SUPPLEMENTAL FINAL ENVIRONMENTAL IMPACT STATEMENT (SFEIS)

River Knoll

**40 CROTON DAM ROAD
TOWN OF OSSINING
WESTCHESTER COUNTY, NY**

December 2022
June 01, 2023

On-site Delineated Wetlands
Figure 3.B-3

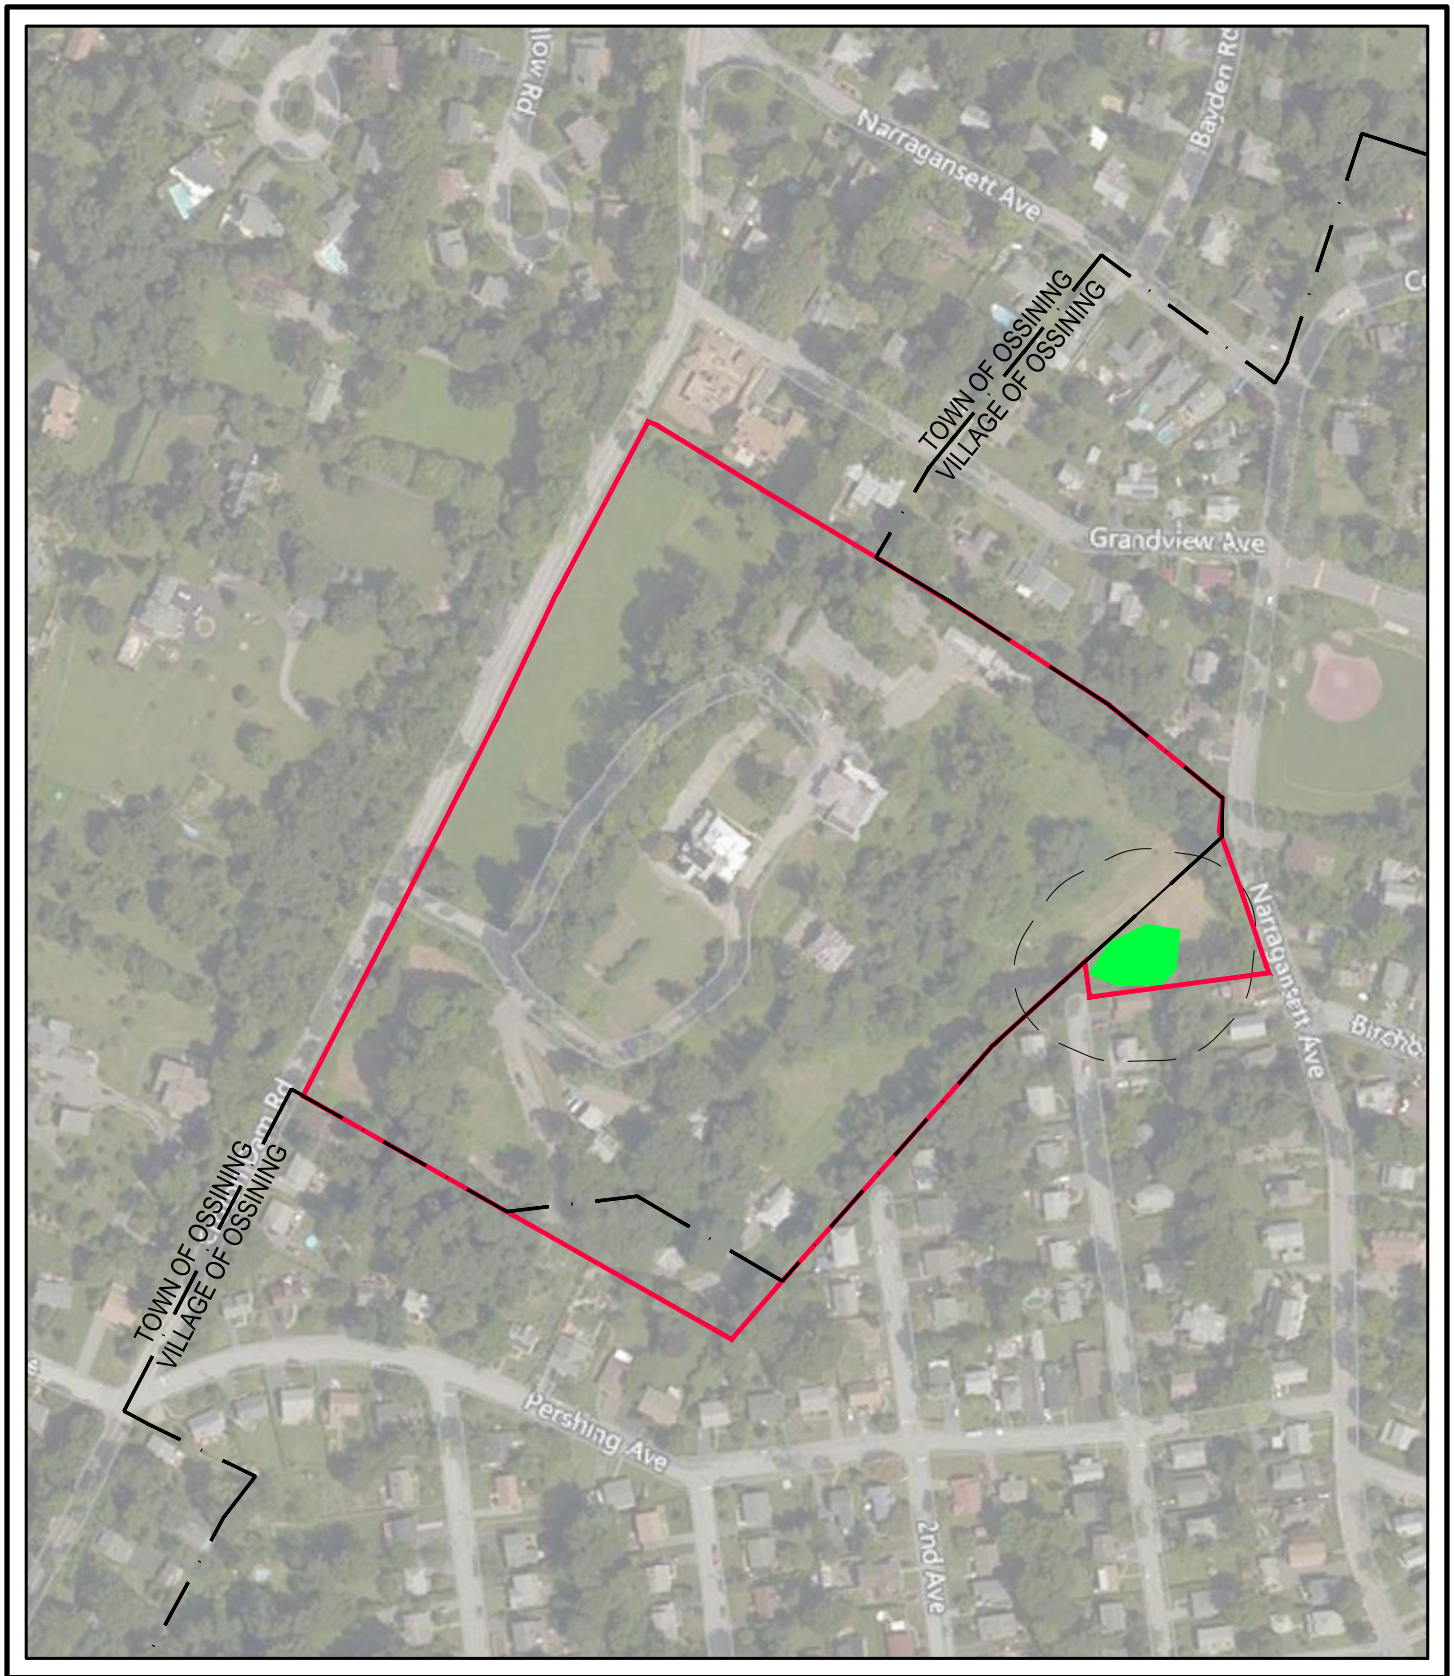
Section III.B.2.i indicates that “the inspections confirmed one small herbaceous wetland of approximately 0.146 acres in size in the northeastern portion of the Project site (see Figure 3.B-3). The wetland is located entirely within the Village of Ossining. The wetland buffer in the Town portion of the site is 0.496 acres in size.” However, III.B.1 indicates that the delineated wetlands within the boundary of the Former Project as such: “a small herbaceous wetland was delineated on-site on September 14, 2015. This wetland was 0.277 acres in size, of which most, 0.273 acres, was located within the Village of Ossining. A smaller amount, 0.004 acres, was located within the Town of Ossining.” Are these statements referencing the same wetland areas? If so, please explain in further detail the discrepancies in size (i.e., why has the wetland area decreased almost by ½ in size from 2015 to 2021?)

This figure has been revised to address the comment (see Figure 3.B-3).
